REZONING PLAN FOR:

McCRAY SELF STORAGE
"PARK A TOY"

PETITION NO: Z-90

PLANNING COMMENTS: **Staff Member Responsible:** John P. Pederson, AICP

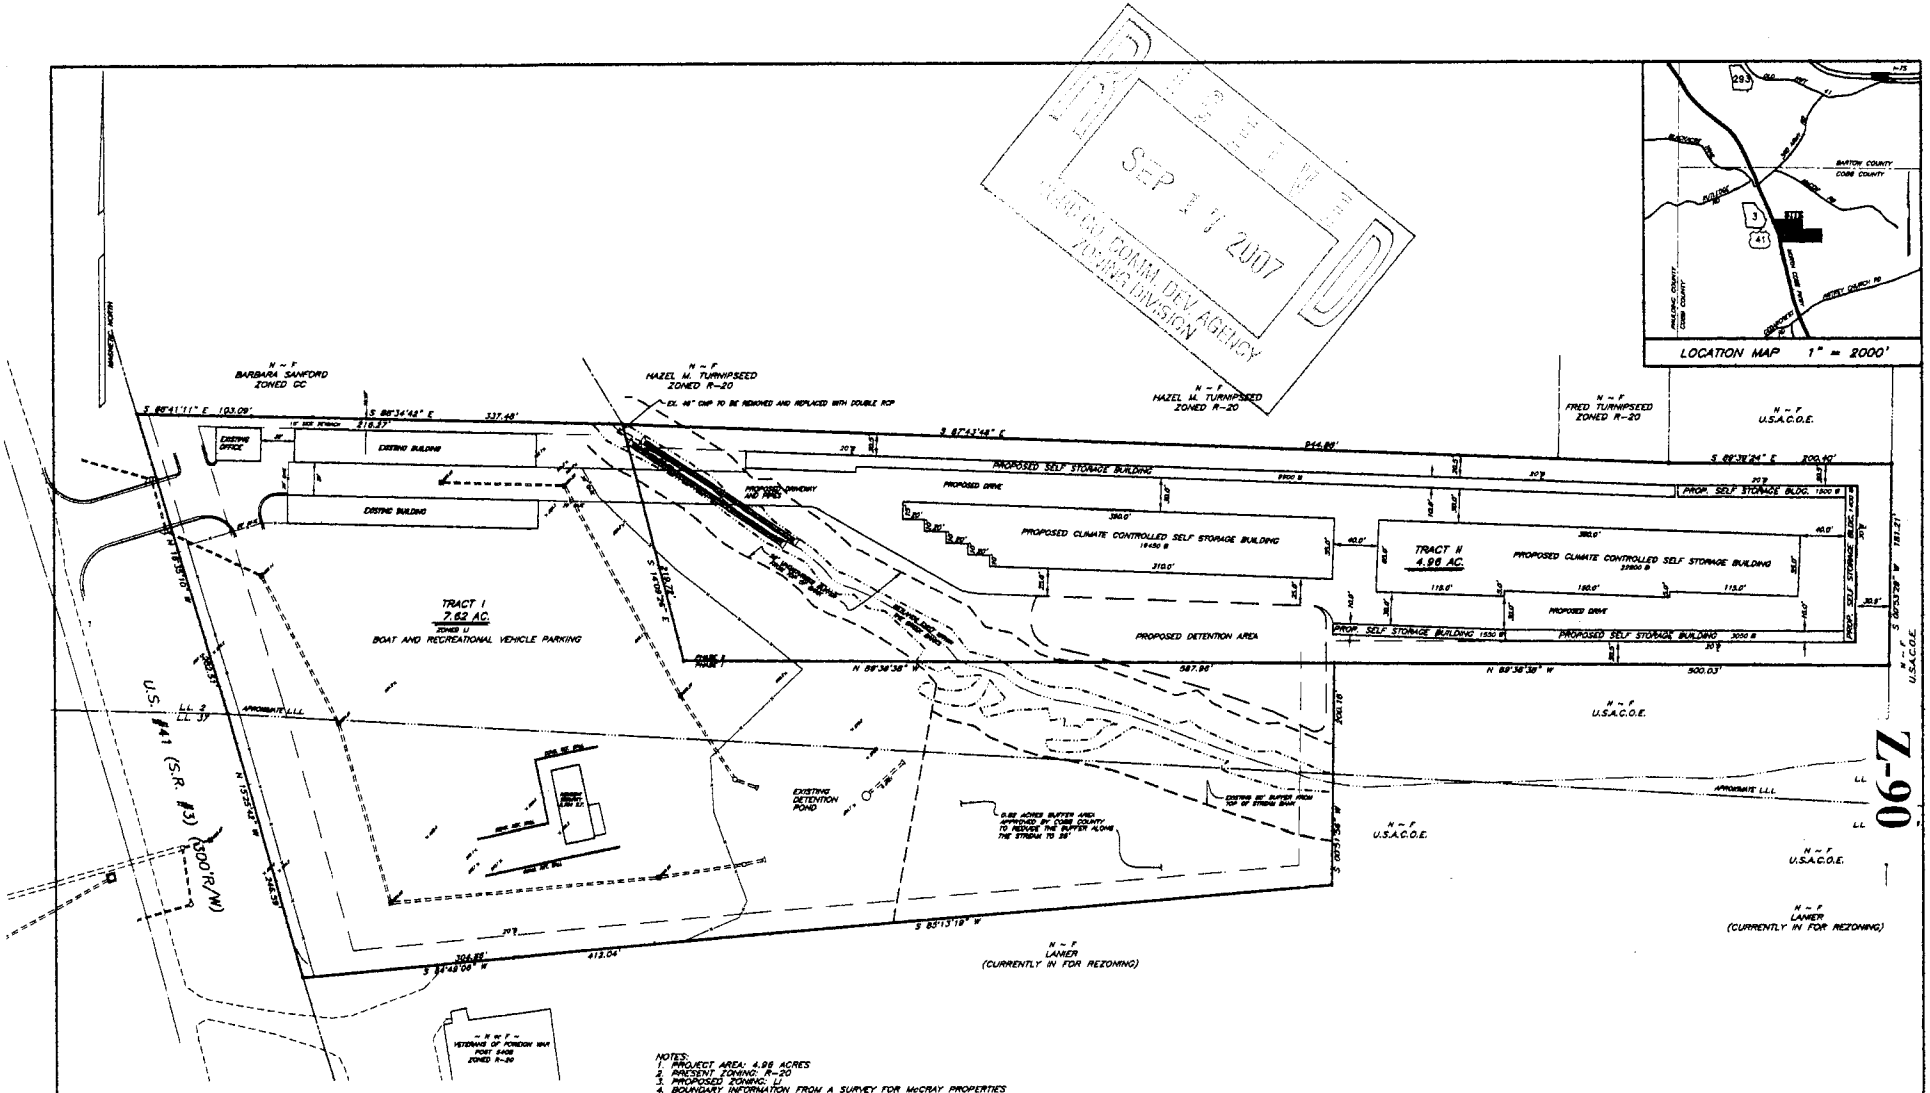
1. Slopes on the proposed site expansion are predominately 15% but approach 20 – 24% at the eastern end. Significant grading will be required to flatten the site for expansion of the existing self-storage facility.

2. Although a stream buffer variance was approved for the existing facility, regulatory guidelines have changed since this project was approved. A field determination of the stream classification must be performed to verify the required stream buffer limits. If the stream is intermittent then the buffer is 50' . If the stream is perennial the required stream buffer is 100' with an additional 50' impervious setback. This will significantly impact the site layout.

3. The proposed culvert extension will result in approximately 130 lf of additional stream impact and will require permitting through the Corps of Engineers. The proposed culvert must be designed to not increase 100-year pool elevations on the adjacent upstream property.

4. The proposed detention pond area is located partially in the stream buffer and appears to be inadequate in size for the impervious area proposed. Due to the close proximity of Lake Allatoona to this site, the First Flush Water Quality Best Management Practice Requirements should be elevated to the 1.5-inch rainfall event and enhanced grassed swales utilized where possible in lieu of a piped system to provide additional runoff infiltration.

Recommend providing inter-parcel access with adjacent self storage development.
